Minutes from the Planning Commission Meeting of July 29, 2008

Comment 1: Commissioner Ostrom

IMPACT: Traffic

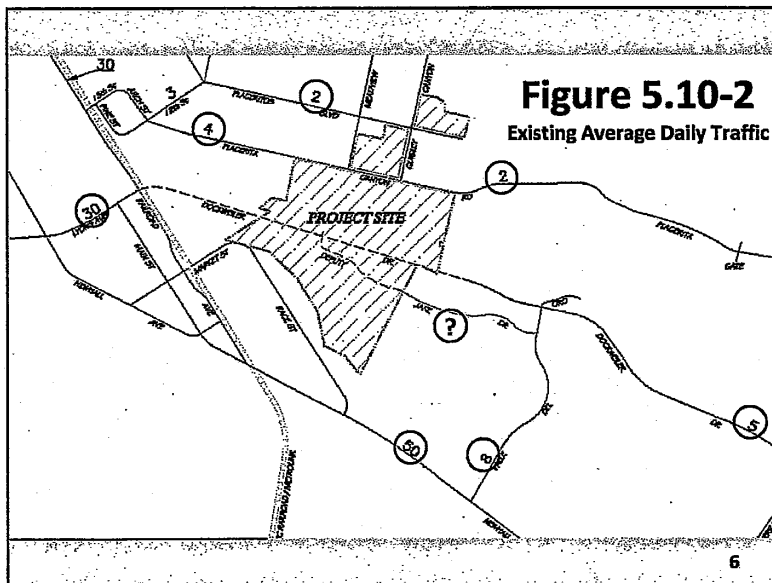
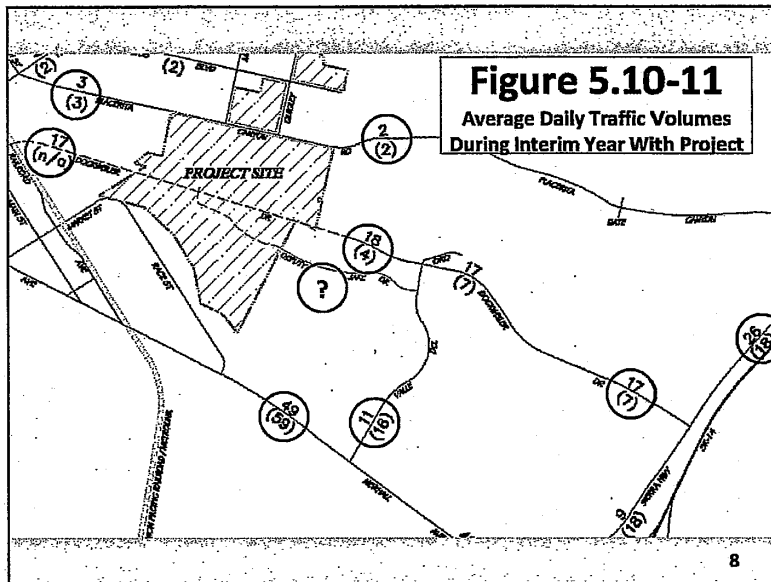
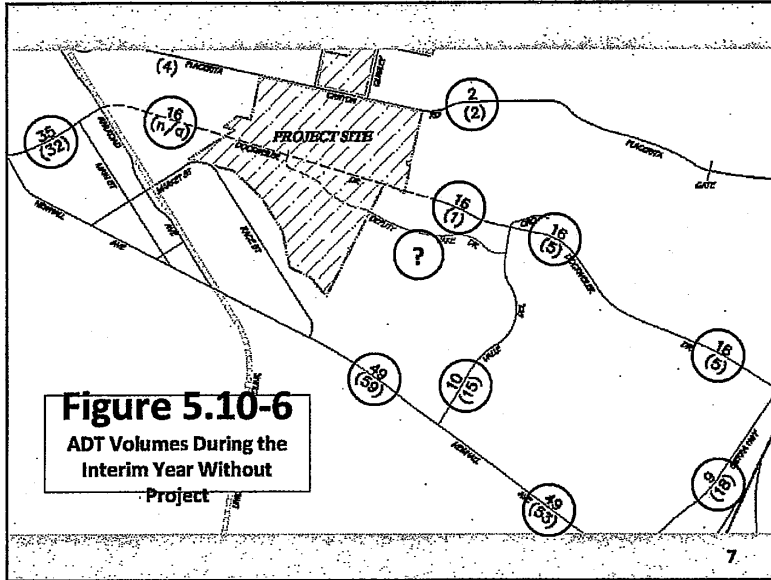
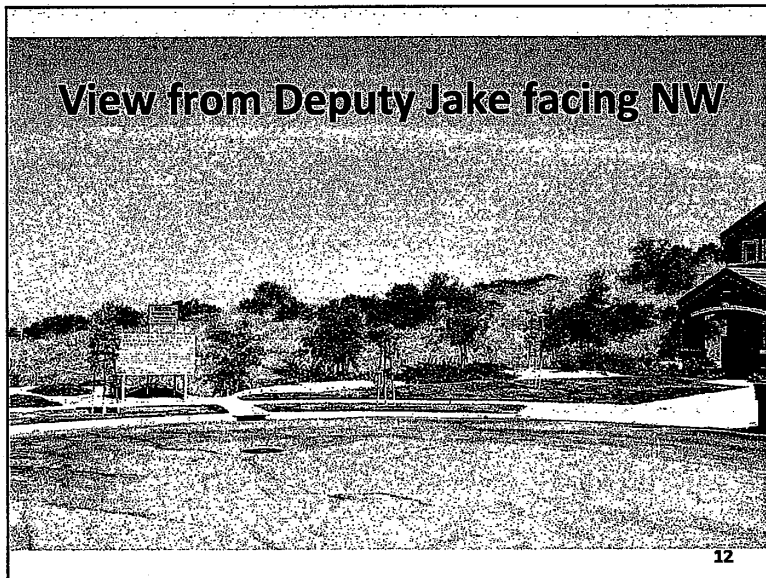
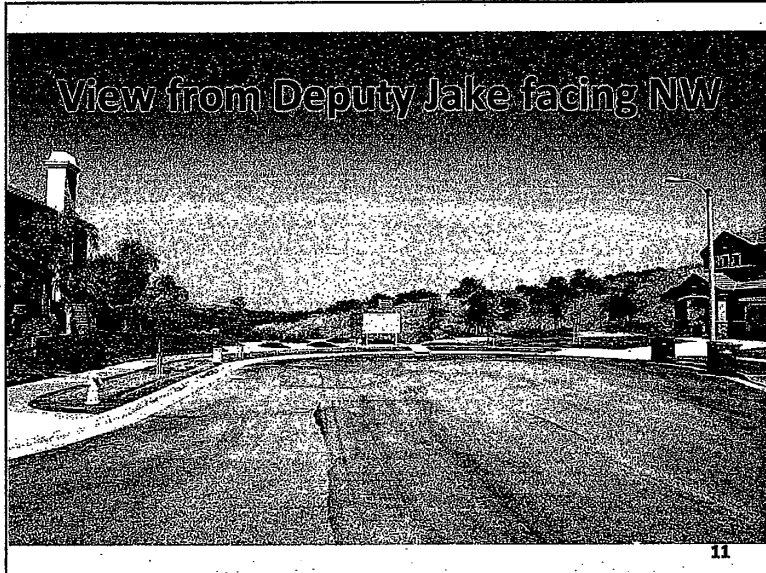
- Figure 5.10-2: Existing Average Daily Traffic
- Figure 5.10-6: Average Daily Traffic Volumes During the Interim Year Without Project
- Figure 5.10-11: Average Daily Traffic Volumes During Interim Year With Project

- **“...increase in traffic which is substantial in relation to the existing traffic load...”**
- **Impact on Deputy Jake: UNKNOWN**

IMPACT: Parking, cont.

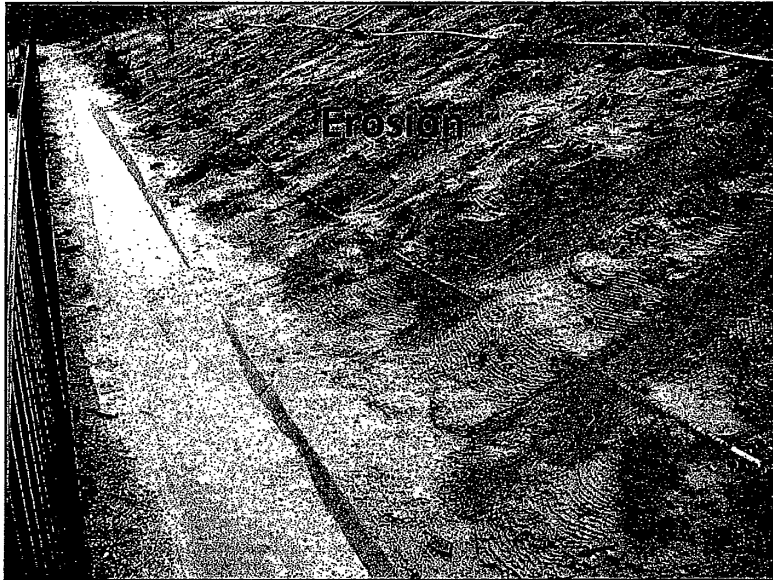
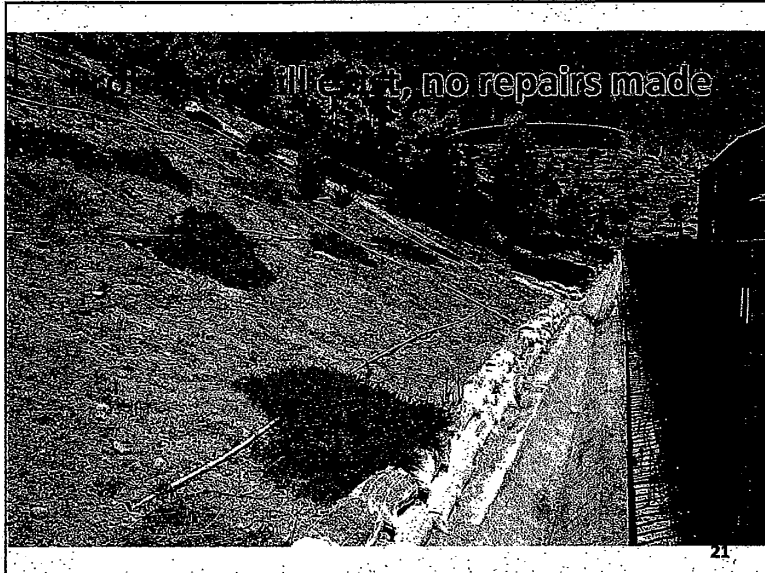
- **Impact of restriping Dockweiler:
UNKNOWN**
- **Comprehensive Parking Survey Is
Needed**

- i. The project applicant is required to analyze the impact of the project as a part of environmental documentation and not provide a parking analysis to the deficiencies of existing developments. However, the project applicant representative was available at the September 2, 2008, Planning Commission public hearing to describe existing parking conditions. (See September 2, 2008, staff report). Please also see the parking study prepared by Linscott, Law and Greenspan included in **Appendix A** to this Final EIR.
